Addendum No. 5
ITB No. 24-15
COURTESY PARKWAY EXTENSION FROM
FLAT SHOALS RD TO OLD COVINGTON
September 27, 2024

ITB #24-15 is hereby amended as follows:

REVISION DATES		SUMMARY QUANTITIES			
△	09/20/2024	COURTESY PARKWAY EXTENSION ROCKDALE COUNTY			
CHECKED:	DATE:	DRAWING No.		06-0001	
BACKCHECKED:	DATE:				
CORRECTED:	DATE:				
VERIFIED:	DATE:

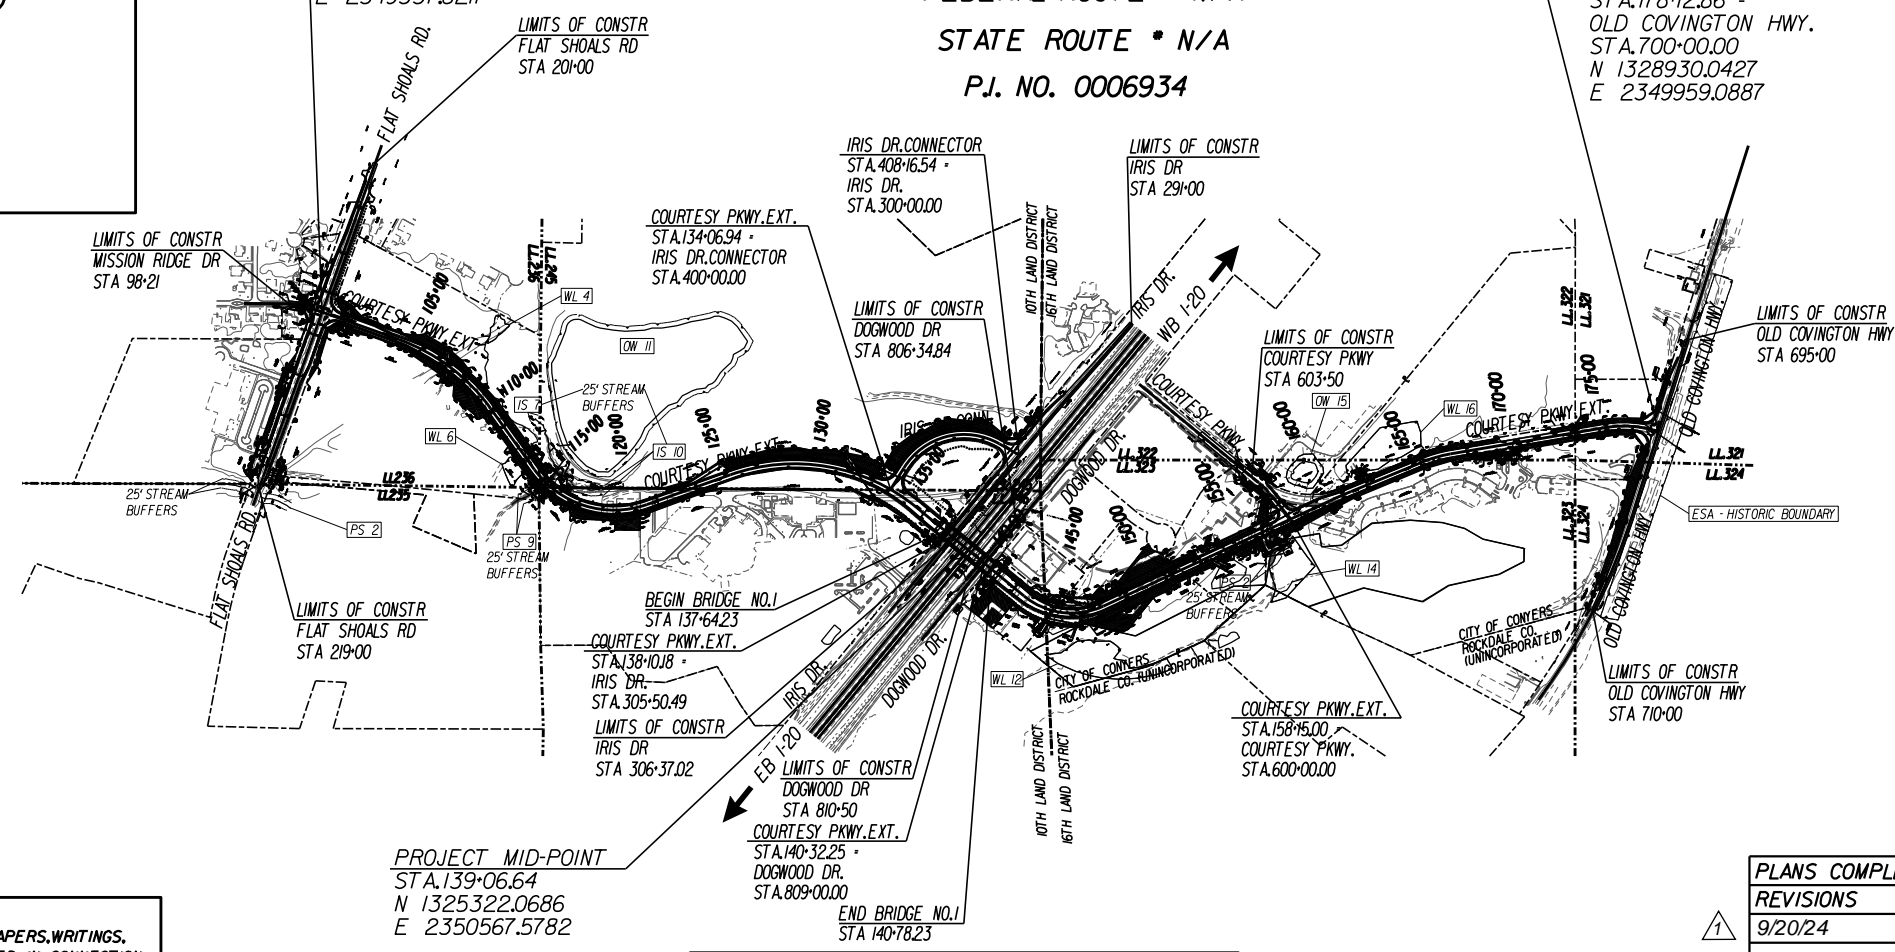
G. Question: The bid quantity for Unclassified Excavation does not match the quantity indicated on the plan sheet (Drawing No. 06-0001). Can you please confirm and update the plans or bid quantity accordingly?

U. Question: The SOQ dwg 06-0001 shows the borrow excavation with a qty of 213,608 CY. The pay item for 206-0002 borrow excavation shows 312,608 CY. Which borrow excavation qty is correct?

Answer: Bid schedule and quantity on drawing No. 06-0001 both show 33759 CY for Unclassified Excavation quantity

Answer: Bid item is being revised with correct qty of 213,608 CY

CHECKED:	DATE:	DRAWING No.
BACKCHECKED:	DATE:	39-0001
CORRECTED:	DATE:	
VERIFIED:	DATE:

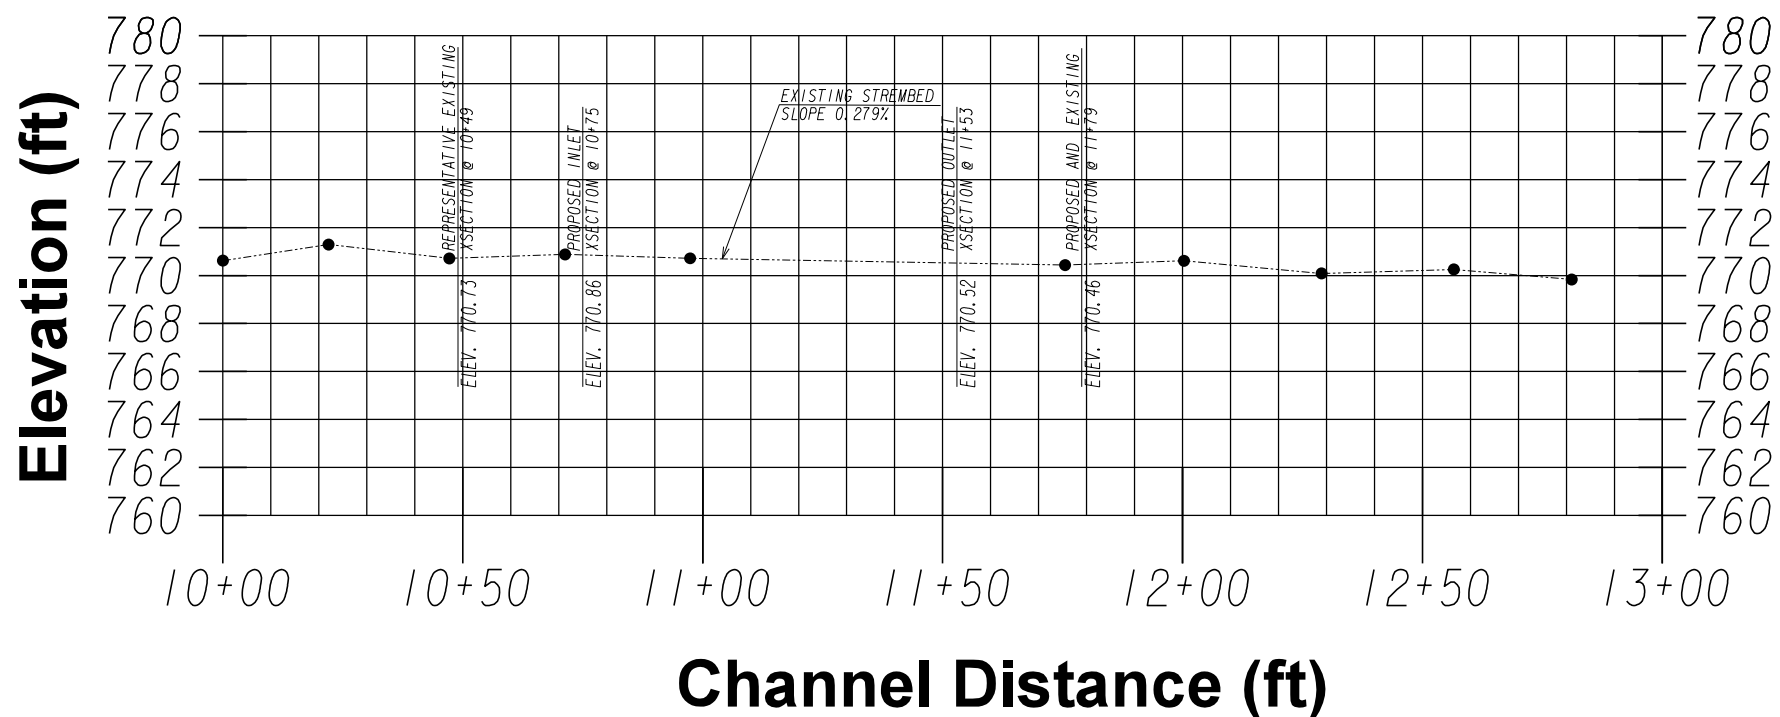
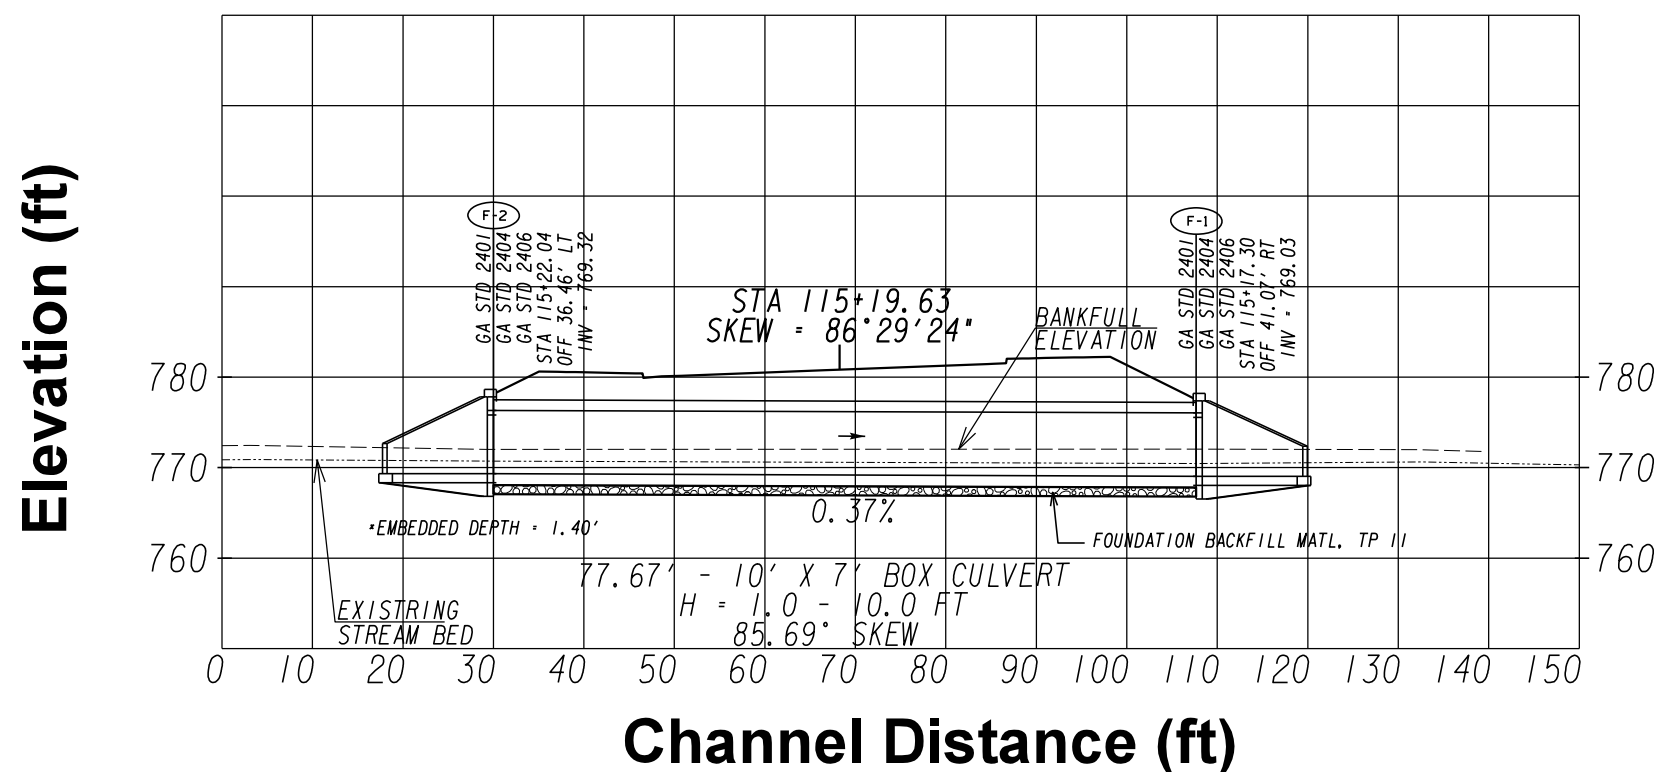
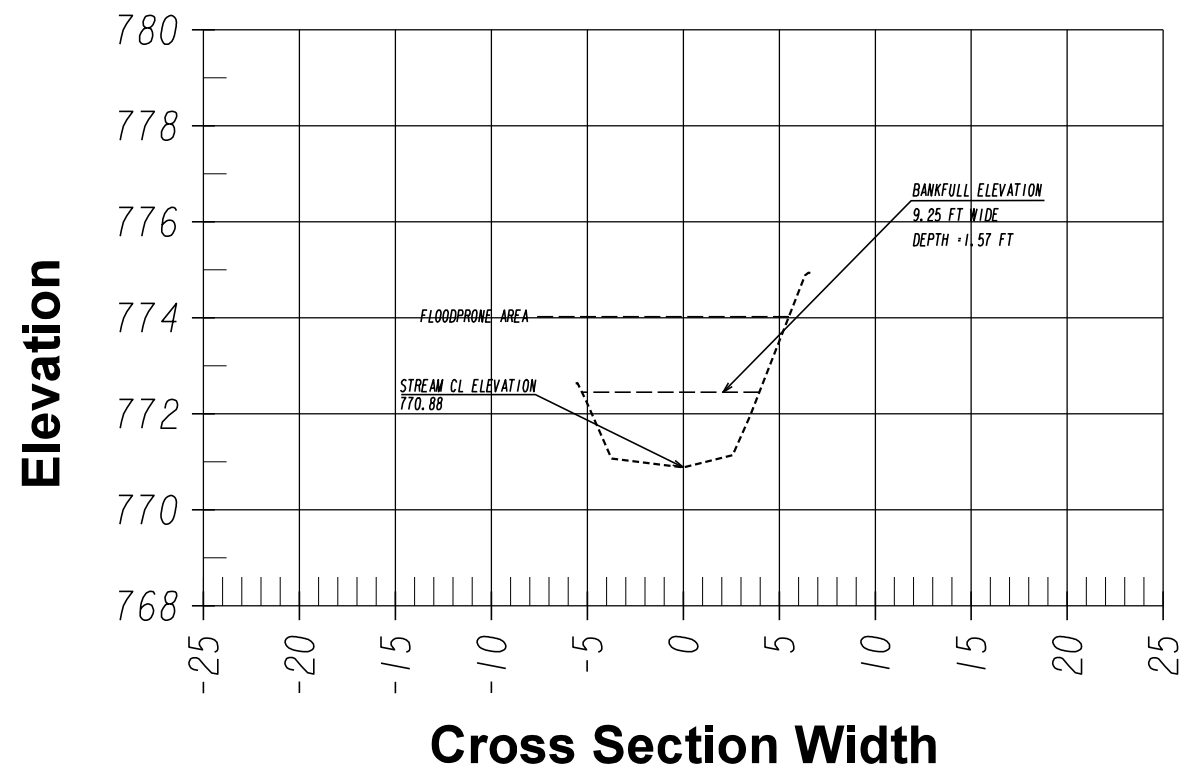
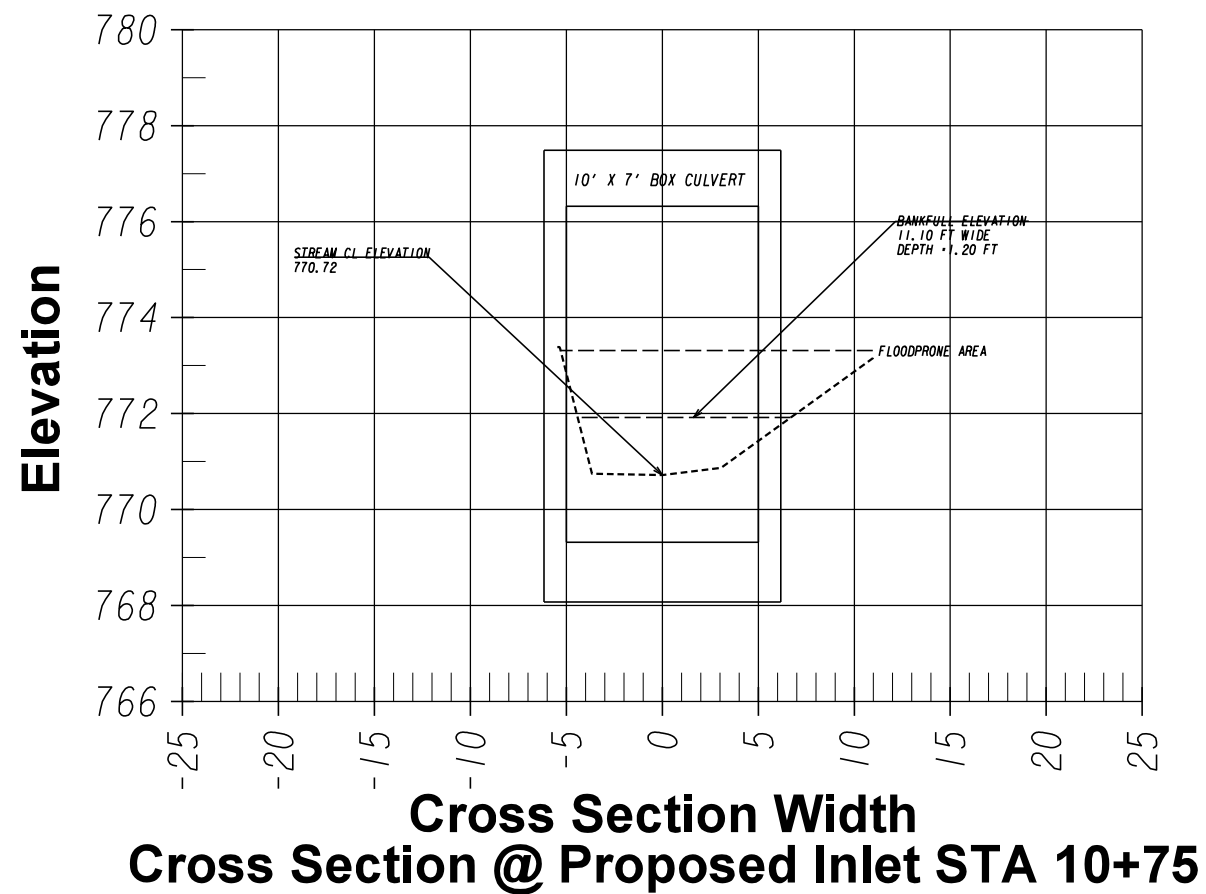
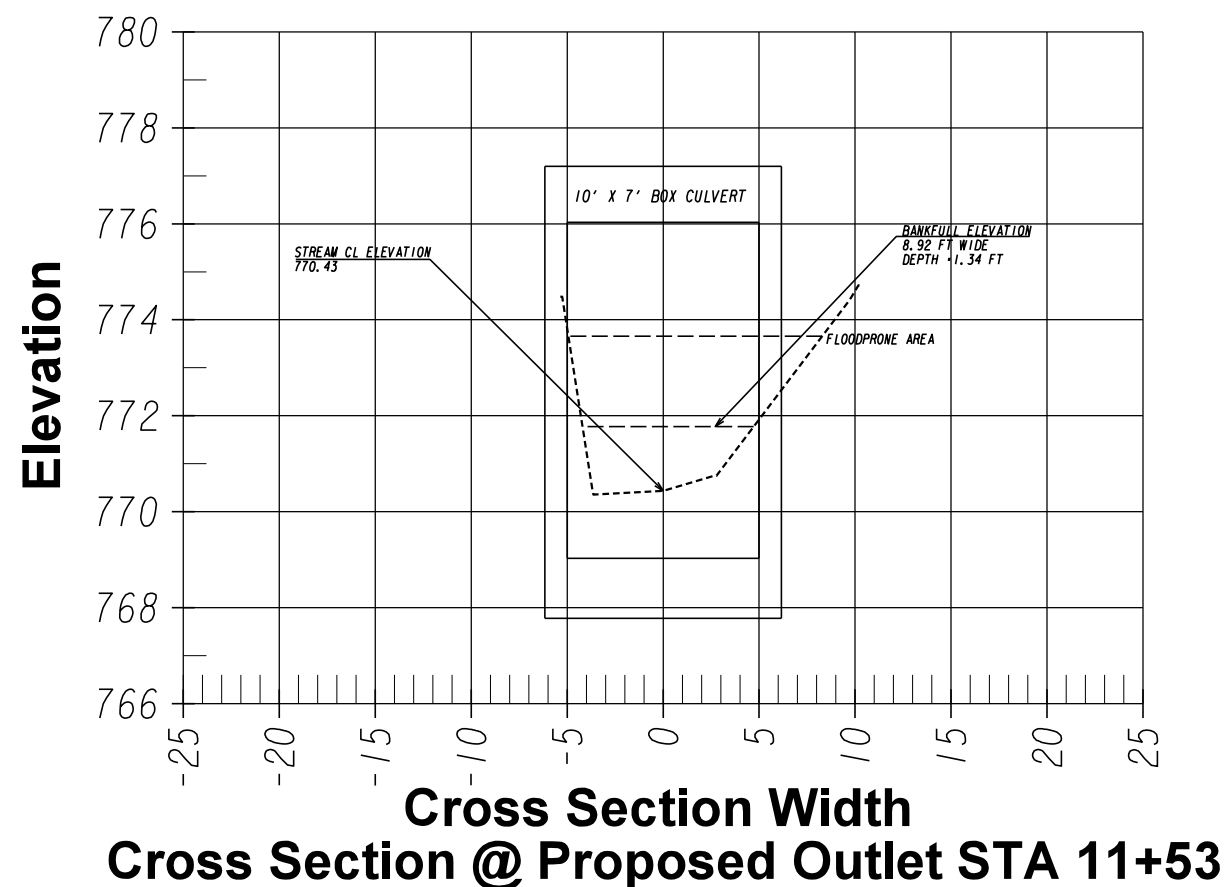
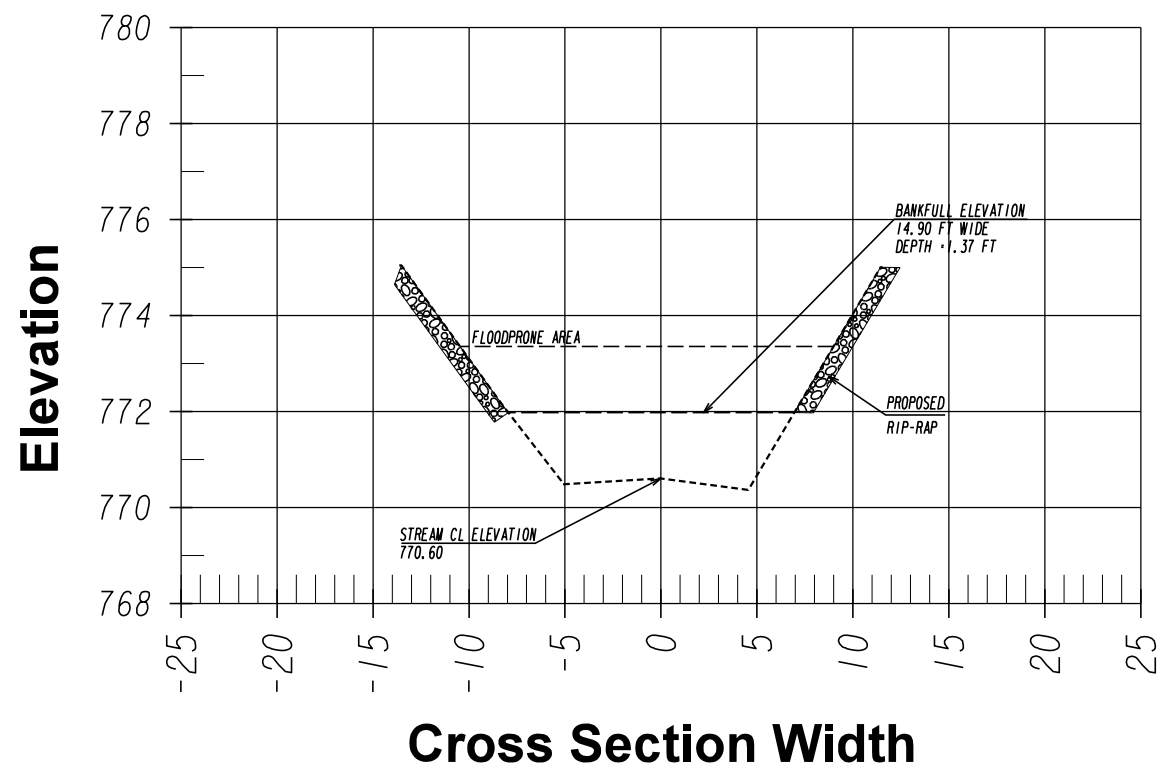
C. Question: Can the County please clarify and provide the information for the Box Culvert Size. The Summary Drawing 06-0007 has it as a 10 X 7, while the Permit Drawings 39-0003 mentions a Double 7 X 6. Which size to consider?

Answer: 39 Series sheets have been updated and are attached to this Addendum for review.
